LSC Responses to PCD Engineering Division Traffic Impact Study Redlines

Copper Chase at Sterling Ranch Traffic Technical Memorandum (LSC #184990) December 14, 2021

PUDSP-22-002

Figures 1-2

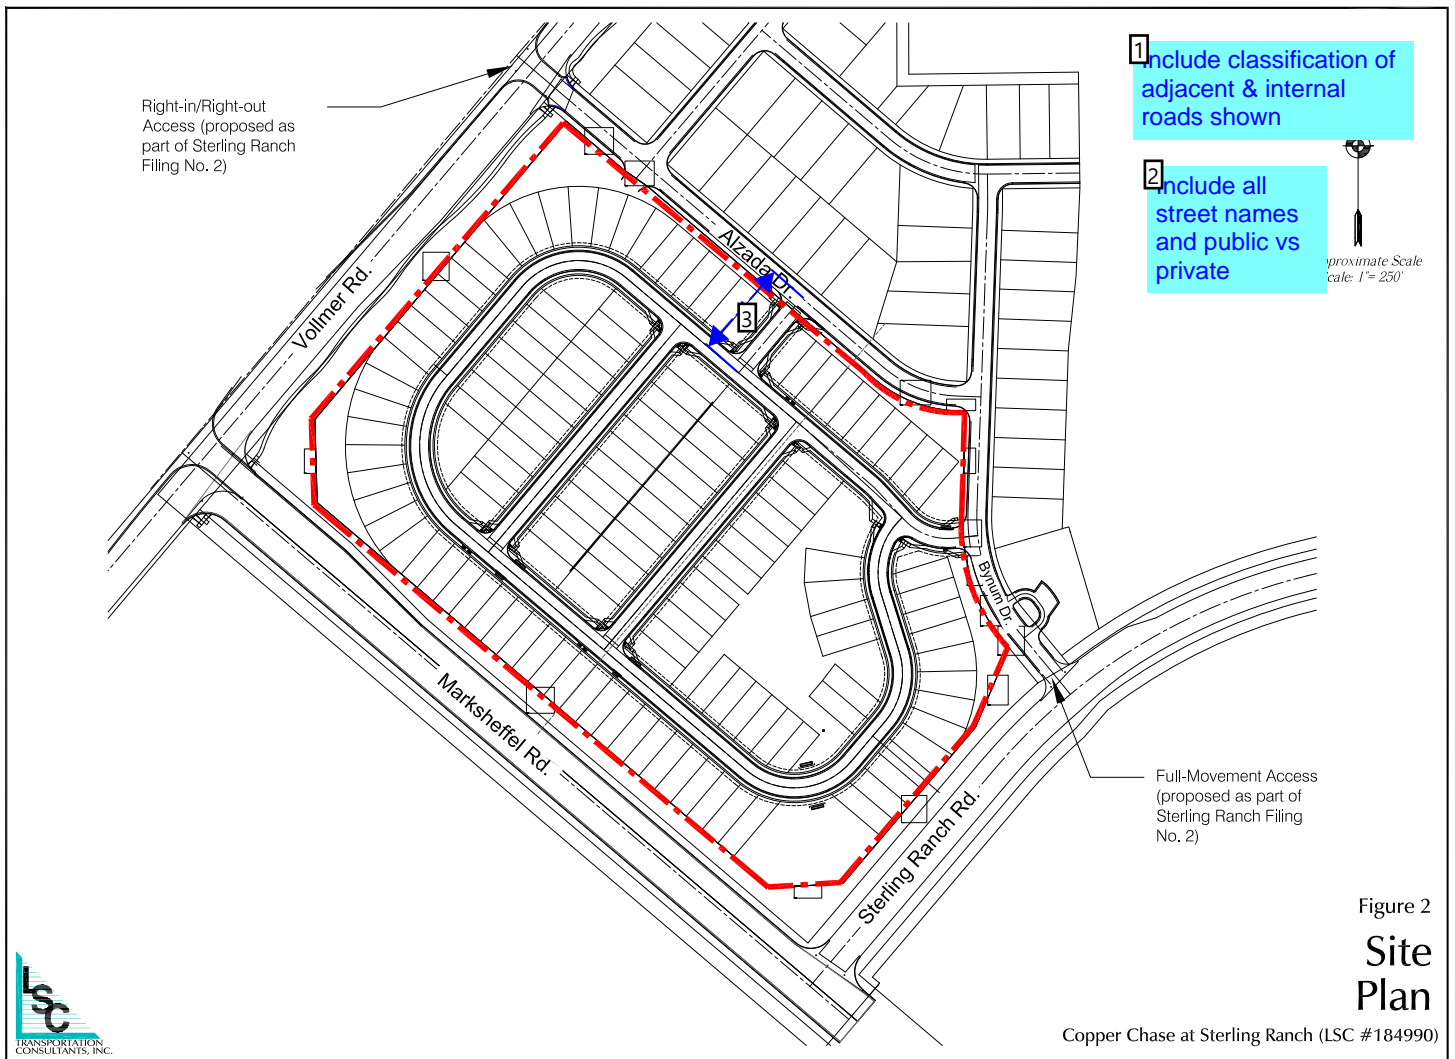
Include school pedestrian plan ¹

[Include school pedestrian plan](#)

[Include classification of adjacent & internal roads shown](#)

[Include all street names and public vs private](#)

x'

LSC Response: Added as requested.

LSC Response: A classification figure has been added as requested.

LSC Response: The requested information has been added to the figure.

LSC Response: The proposed intersection spacing has been added as requested.
